Access Compliance Report

Public Rights-of-Way

(Pedestrian Signals)

Intersection ID: N/A	Main Street:	Cross Street: N/A	Location: N/A
ADA ID: 41894E210D22	Signal Type: One Push Button-Non APS	Overall Compliance: No	Severity Score: BTN 1: N/A BTN 2: N/A No BTN: N/A
Codes/Mitigation Info/Possible Solution		Field Measurements/Component Compliance

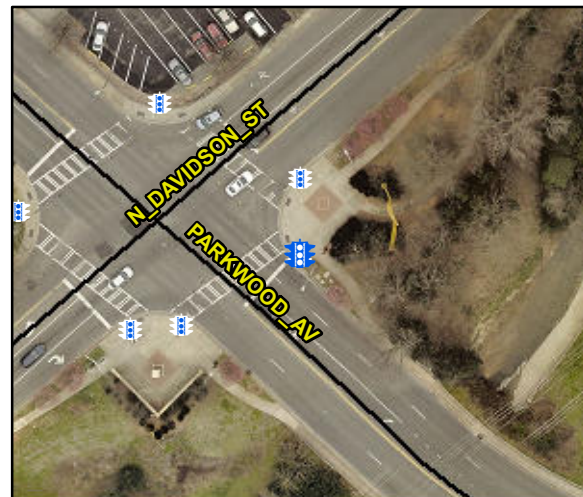
Compliance	Description	Data	Compliance	Description	Data
	Button Count	Button1	Yes	Distant to Additional Button (in)	461.0
	Additional Button Present?	Yes		Additional Button ID	FB6AD961A0C2
N/A	Signal Buttons Required?	N/A	N/A	Additional Ped Posts Required	N/A
	How Many Ped Street Xings?	2		Located In An Island/Median?	No
N/A	B 1 Sign Present?	Yes	N/A	B 2 Sign Present?	N/A
Yes	B 1 Sign Purpose?	Yes	N/A	B 2 Sign Purpose?	N/A
Yes	B 1 Sign Lettering & Contrast?	Yes	N/A	B 2 Sign Lettering & Contrast?	N/A
Yes	B 1 Parallel To XWalk?	Yes	N/A	B 2 Parallel To XWalk?	N/A
Yes	B 1 PAR to Button?	Yes	N/A	B 2 PAR to Button?	N/A
Yes	B 1 PAR to XWalk?	Yes	N/A	B 2 PAR to XWalk?	N/A
Yes	B 1 Clear Floor Space?	Yes	N/A	B 2 Clear Floor Space?	N/A
N/A	B 1 FWD Approach?	Yes	N/A	B 2 FWD Approach?	N/A
N/A	B 1 FWD Approach Constrained?	No	N/A	B 2 FWD Approach Constrained?	N/A
No	B 1 FWD Approach Reach (in)	4.0	N/A	B 2 FWD Approach Reach (in)	N/A

Yes	B 1 Clear Xing Direction?	ClearlyMarked	N/A	B 2 Clear Xing Direction?	N/A
	B 1 Crossing Direction	To SW		B 2 Crossing Direction	N/A
No	B 1 DistanceTo XWalk (in)	106.0	N/A	B 2 DistanceTo XWalk (in)	N/A
Yes	B 1 DistanceTo Curb (in)	53.0	N/A	B 2 DistanceTo Curb (in)	N/A
Yes	B 1 Diameter (in)	2.0	N/A	B 2 Diameter (in)	N/A

Possible Solutions: Replace Signal Push Button With APS Button on New Post. Remove & Relocate Sign.
